PLANNING AND BUILDING DEPARTMENT PLANNING DIVISION

July 05, 2023

Re: Building Permit Application No. 0361781, AN 117-210-061-000

Figure 3.2.A

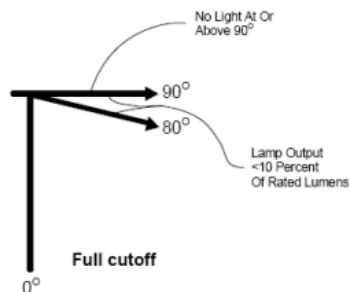
- a. Please provide highlighted cutsheets that identify which fixtures and their associated add-ons if any. I was unable to find within the cutsheets information that demonstrate all fixtures meet the full cutoff definition.

“Full-cutoff (fco)” means the light distribution of a luminaire where zero units of light intensity occurs at an angle of 90 degrees and greater above nadir, which is the vertical point directly below the luminaire when it is pointed down (0 degrees), and does not exceed 10 percent of lumen output at a vertical angle of 80 degrees above nadir, as demonstrated in Figure 3.2.A, below. This applies to all lateral angles around the installed luminaire to include any tilt or other non-level mounting condition. [Illuminating Engineering Society of North America (IESNA) Standards]. Full cut-off does not have the same meaning as and cannot be used interchangeably with the terms ‘cut-off’, ‘full shielding’ or ‘fully shielded’.
